Lake Los Carneros Trail Management, Rehabilitation And Interpretive Program Review

Santa Barbara County Trails Council • September 2009

The purpose of this review is to provide the City of Goleta with guidance in the formulation of a trail management plan for Lake Los Carneros.

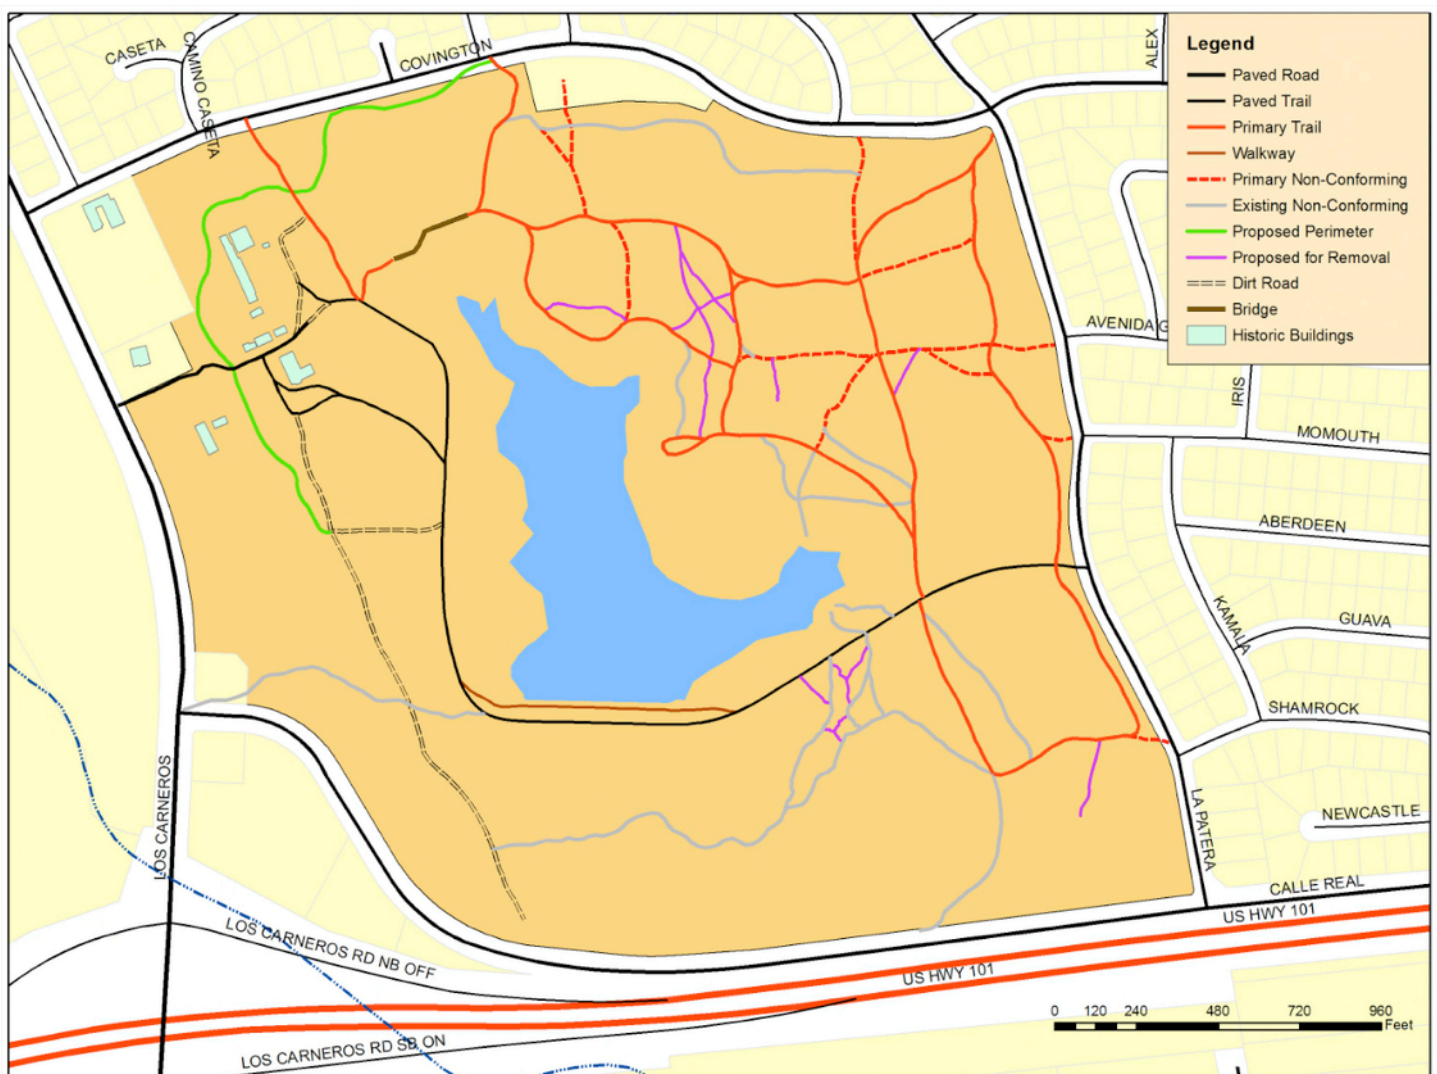
Figure 2. Map shows current trail locations throughout Lake Los Carneros, including the Primary Trails recommended by Penfield & Smith, several types of non-conforming trails, including connections to the primary trails, lesser used routes (shown in gray) as well as a number of other routes recommended for elimination (shown in purple). The result is a poorly designed and maintained network of trails that is in need of update.

The Trails Council recommends the City of Goleta begin a process of identifying trails at Lake Los Carneros suitable to be part of the larger network of trails, standards to be applied in maintaining them and criteria for removing those that no longer serve a useful purpose.

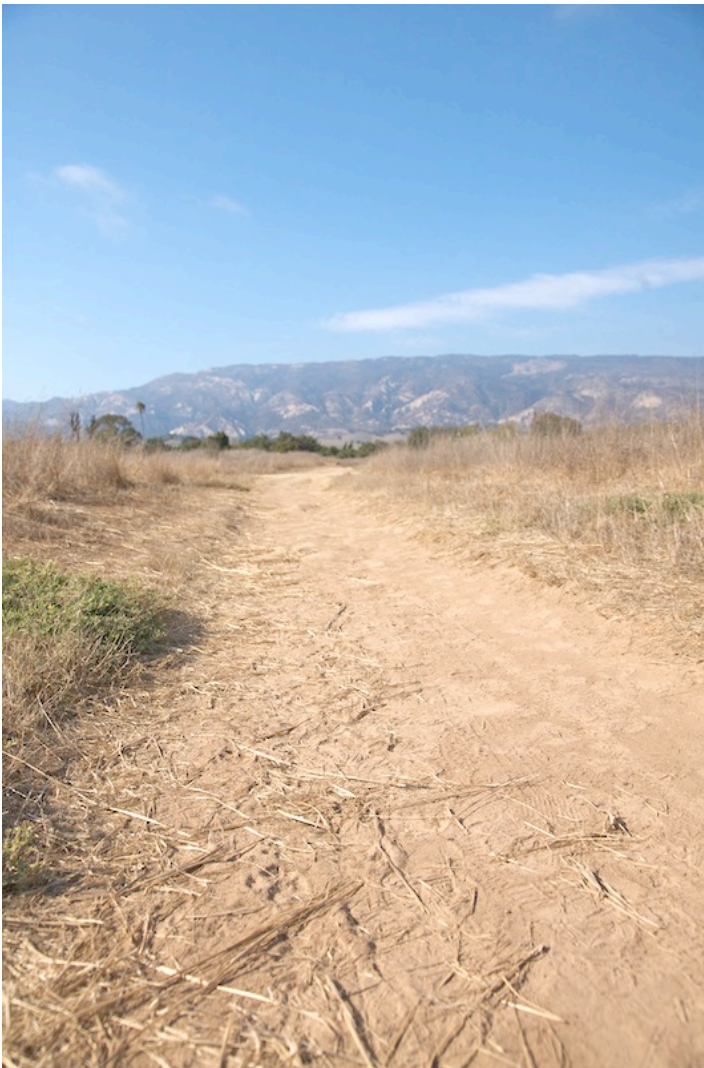
Trail on the right is typical of many of the Primary Trails though in need of maintenance due to gullyng. Grass has been cut back 5- 6' on either side, encouraging users to wander off of the existing tread. Some erosion control is needed to minimize gullyng.

SBTC recommends that trails designated as Primary Trails be a minimum of 4' wide and no wider than 6'. In a recent survey of the trails, it was noted that where the primary trails were less than four feet wide parallel trails often

- Trail Tread—should be smooth and graded to avoid the excessive erosion that causes gullyng.
- Sight lines—should extend at least 50' where possible so users can see one another well ahead of meeting each other.
- Meadow grass—should be mowed back a minimum of 2' off either side of the trail tread but not so far as to encourage users to travel off the tread and unintentionally contribute to trail widening.
- Brush should be trimmed back to provide a trail corridor of at least 2' beyond either side of the trail and be done to maintain sight lines as described above.

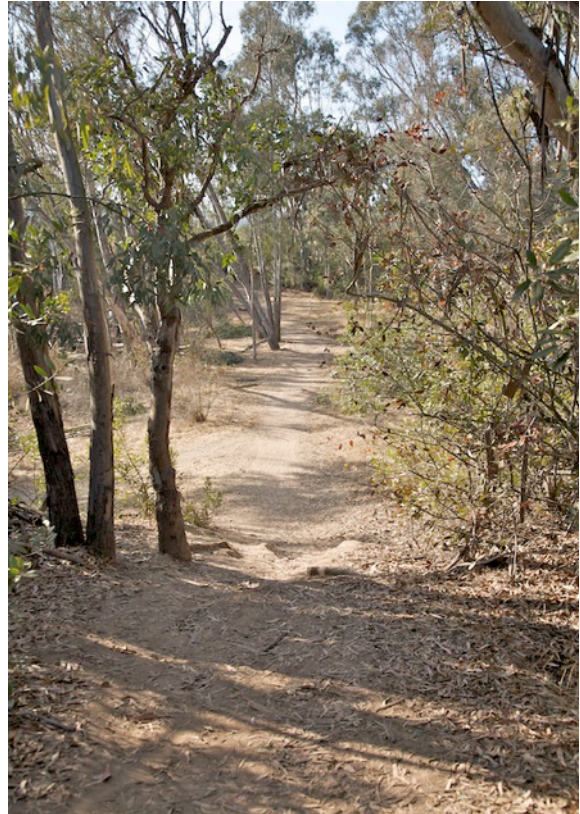
Trail on left has tread that is about 6' wide and approximately 12" below surrounding meadow areas, making it impossible for water to travel anywhere but down the trail. Trail segment on the right is severely gullied, forcing users to the right or left of the channel and widening the trail. Note that the trail narrows again in the distance where the gullying no longer occurs.

Dealing with the tread issues is complicated by the fact that many of the trails are located on parts of the park that are level or almost level. Erosion over the past several decades, while slight, has resulted the trail tread that is below grade in a number of places. Practically speaking, this means that the tread surface is below the surrounding meadows, making it difficult to get water off the trail. SBTC recommends "meandering" the trail in places, using short re-routes to move the trail off the existing tread, up onto higher ground and then back onto existing tread to vary the trail elevation while adding soil in some areas to bring the trail back up to the level of the surrounding areas.

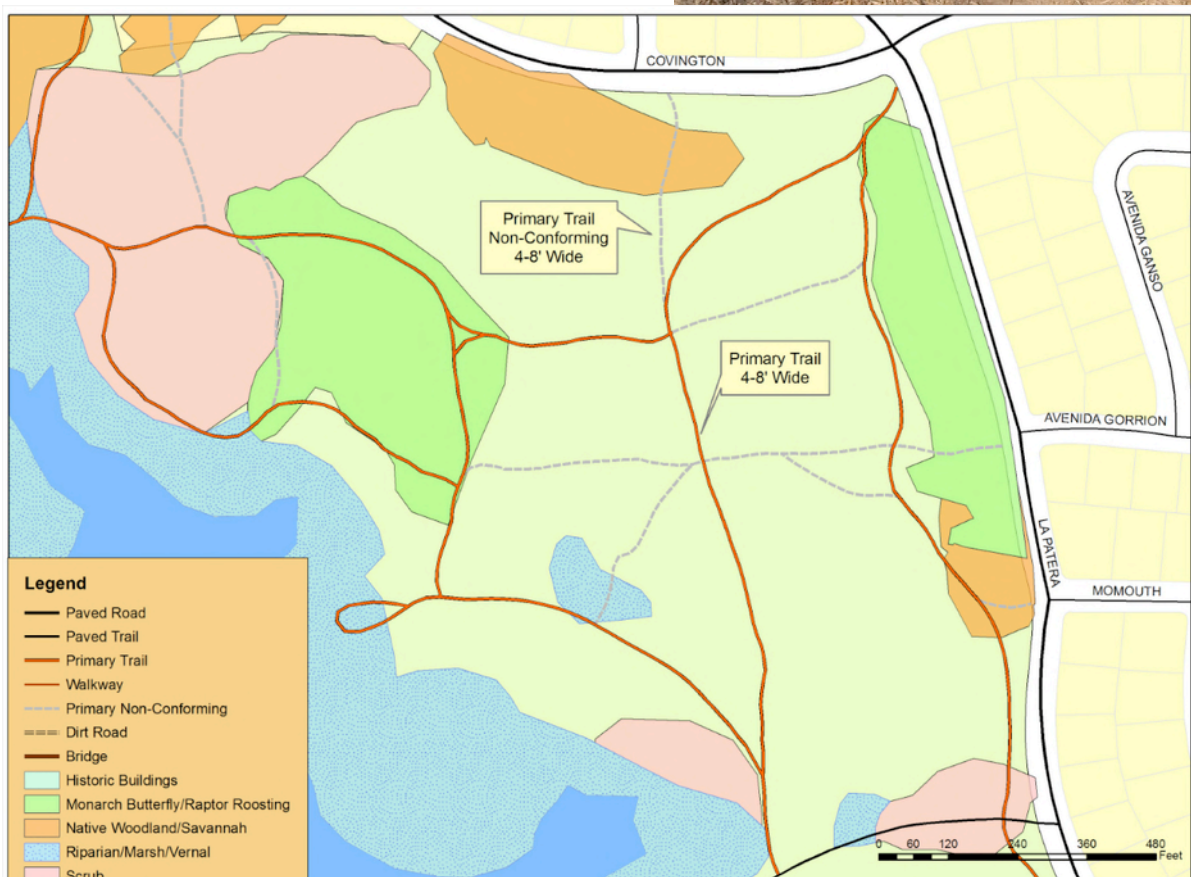
Trail segments that all need improvements including widening the tread in the upper left; narrowing the tread width in the upper right; and brushing to improve sight lines in the lower left and lower right. Note the lower right trail section drops too steeply down into the eucalyptus “bowl.” Re-routing to the right to lessen the grade would be helpful.

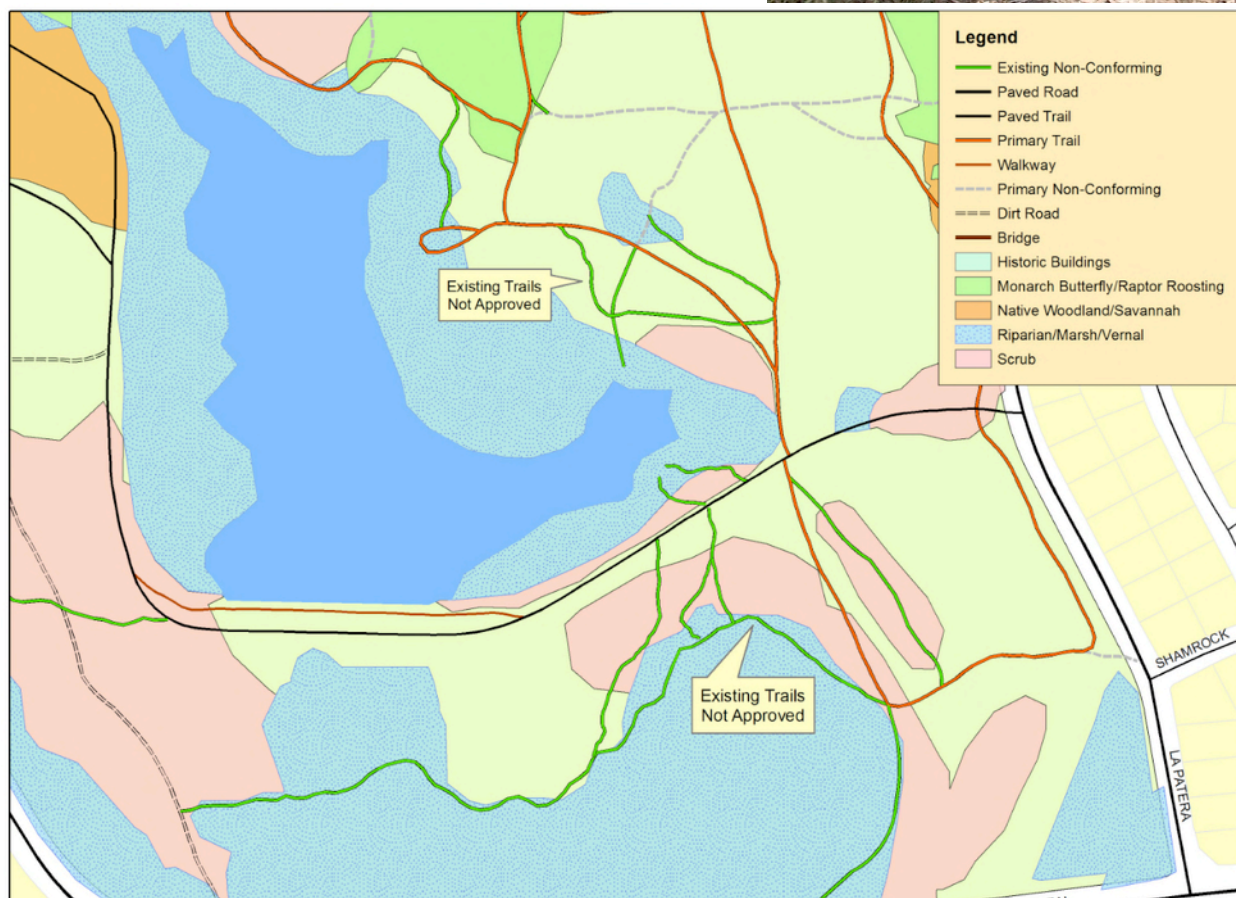
Trail on right is typical of many of the more primitive trails that SBTC has classified as “non-conforming.” Though it is suitable for the public, it needs both brush and line-of-sight improvements. However, issues such as habitat or wildlife values, however, may make it unsuitable for other reasons. Map below shows non-conforming trails overlaid on top of habitat.

- Trail Tread—should be smooth and graded but no more than 24” in width
- Sight lines—may extend to as little as 25’ and trail users need to exercise more vigilance in looking out for others.
- Meadow grass—should be mowed back a minimum of 1-2’ off either side of the trail tread to define the tread. Because the terrain is not as amenable, mowing will need to be done by hand.
- Brush should be trimmed back to provide a trail corridor of at least 2’ beyond either side of the trail and be done to maintain sight lines as described above.
- Dips and/or waterbars should be added where appropriate to control the flow of water and get it off the trail.

Figure 5. Many of the trails proposed for removal go nowhere, have serious erosion issues, provide shortcuts of little value or pass through sensitive wildlife habitat.

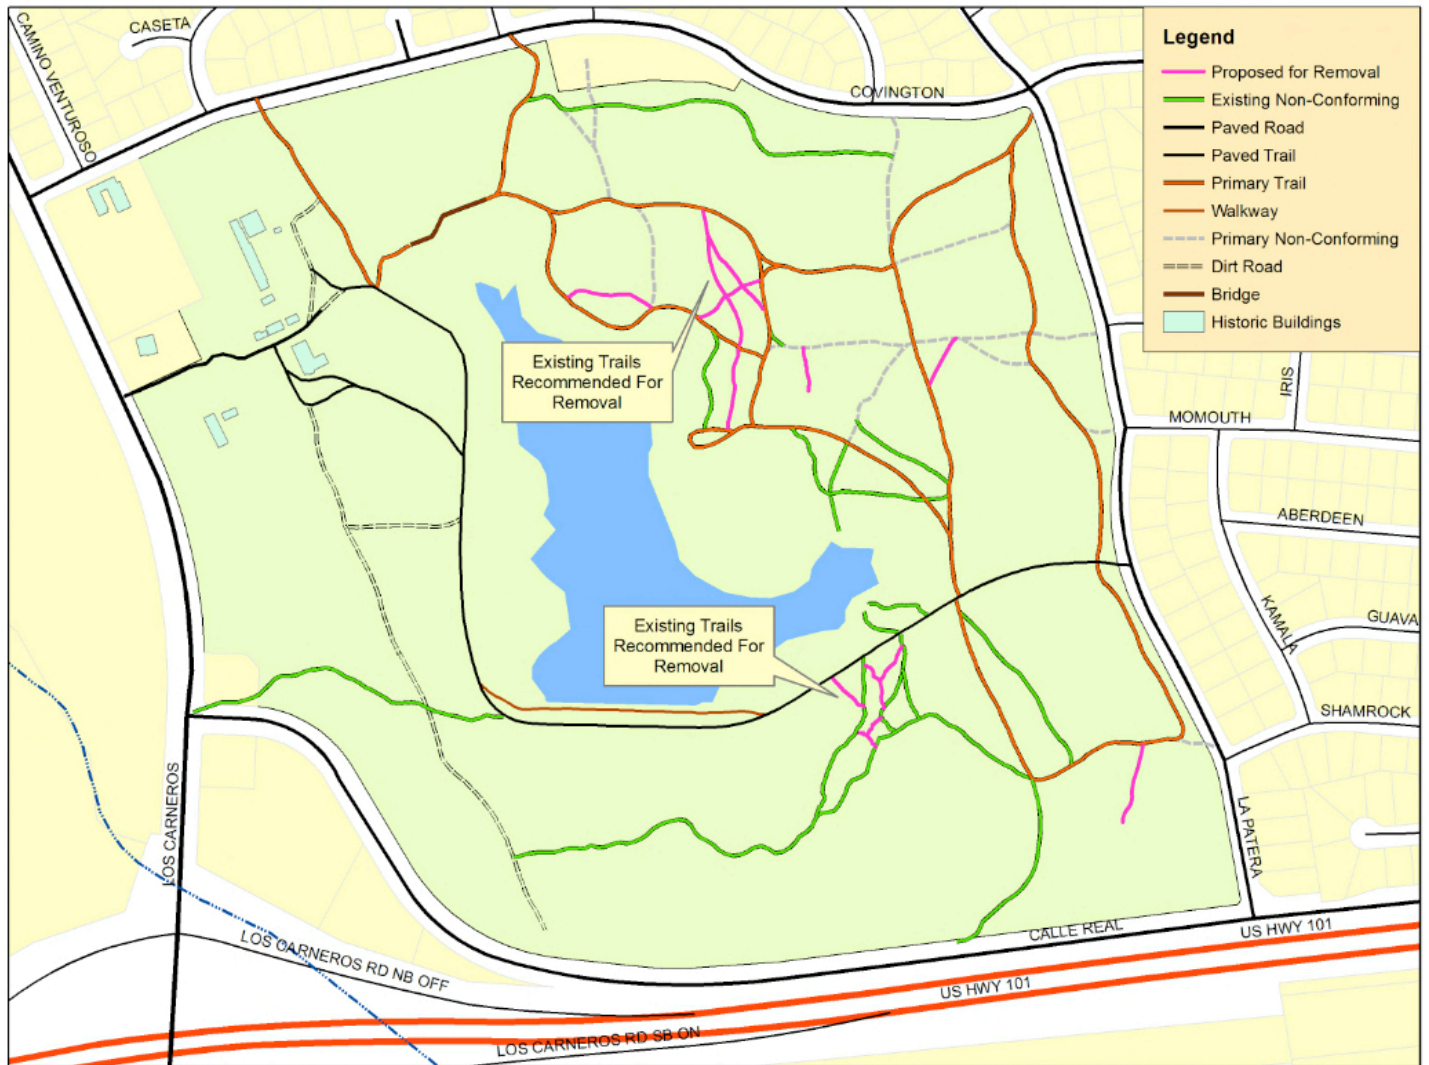
SBTC has identified a number of other non-conforming trails (shown in purple) in Figure 5 that we believe either serve little purpose, impact habitat or other values too much or increase erosion to the point that they need to be removed. For these reasons we recommend they be eliminated.

Removing existing trails provides their own challenges. While complete restoration of a site involves a fairly complex and long-lasting process, SBTC proposes an initial set of steps designed to direct the public away from entry points for the trails being removed and towards existing approved trails. This can be accomplished by:

- Digging up the trail tread to loosen compacted soil along the tread and discourage use.
- Spreading vegetation, branches and other materials along the trail to provide a more natural look and hide the old trail.
- Planting native vegetation at the entry points to these trails, thus cutting off entry to them as well as contributing to the natural setting.
